# CITY OF ALBUQUERQUE

**RE: San Antonio Commons (Office / Retail)**  
**Grading and Drainage Plan (Stamp Date 12-14-15)**  
**Hydrology File: E18D59**

Based upon the information provided in your submittal received 12-15-15, the above-referenced plan cannot be approved for Grading Permit and Paving Permit until the following item is addressed:

GRADING & DRAINAGE  
PLAN

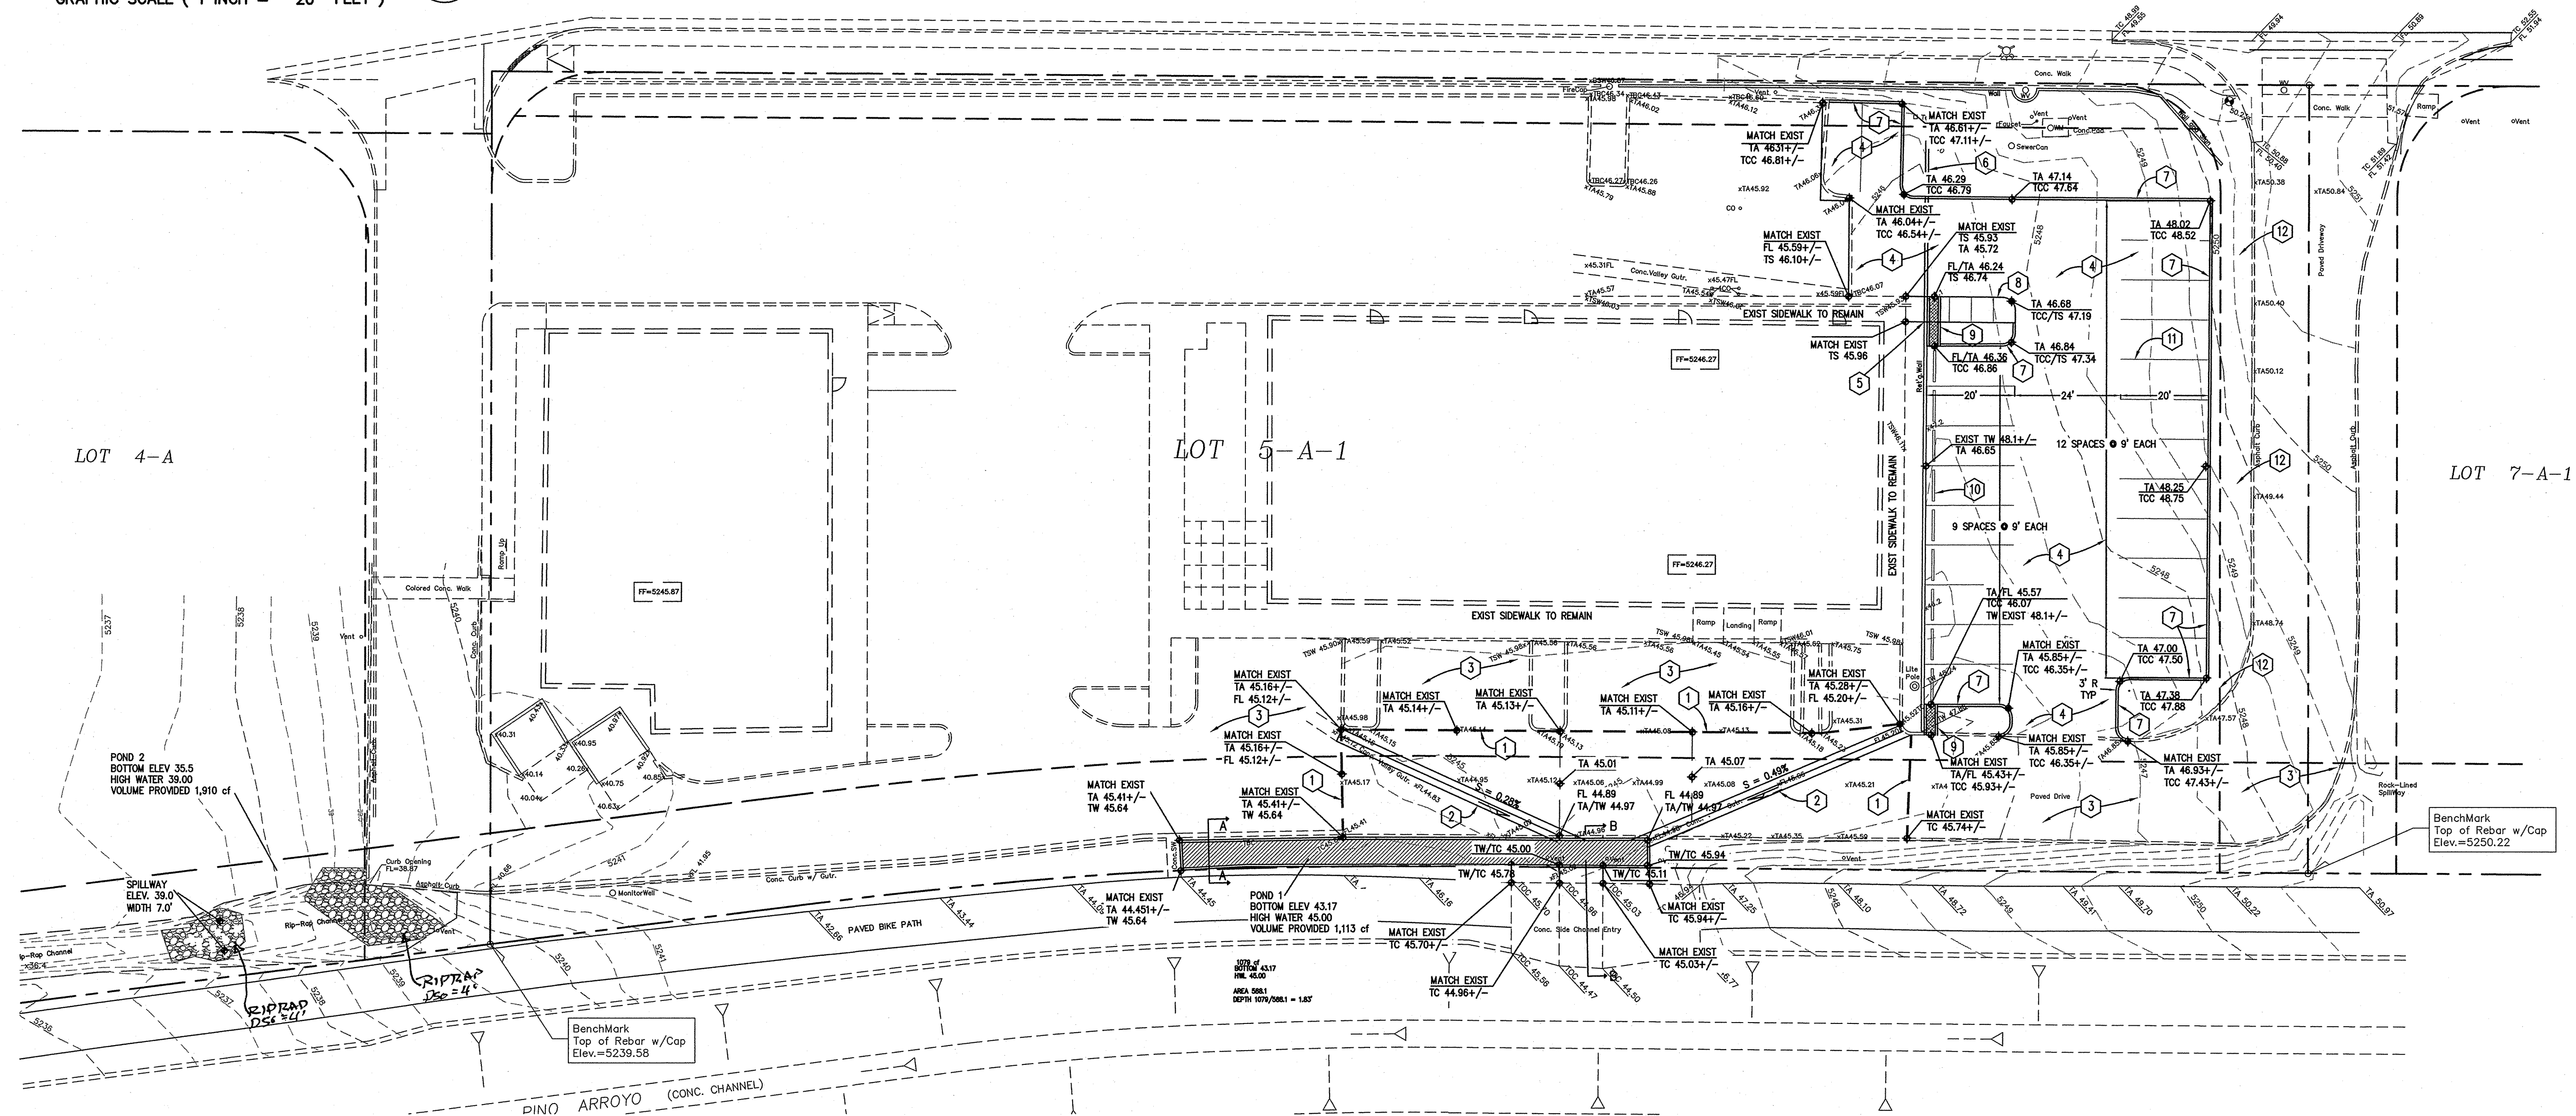
The effort made on the plan to address the City's first flush is greatly appreciated. However, the Environmental Health Department of the City has advised against retaining any Stormwater on this site. The concern is related to the old landfill site that exists in the area and settling that has been observed along the San Antonio corridor. Instead of constructing a retention pond, the City requests that a water quality feature is considered, that removes debris and floatables, and oil if practicable.
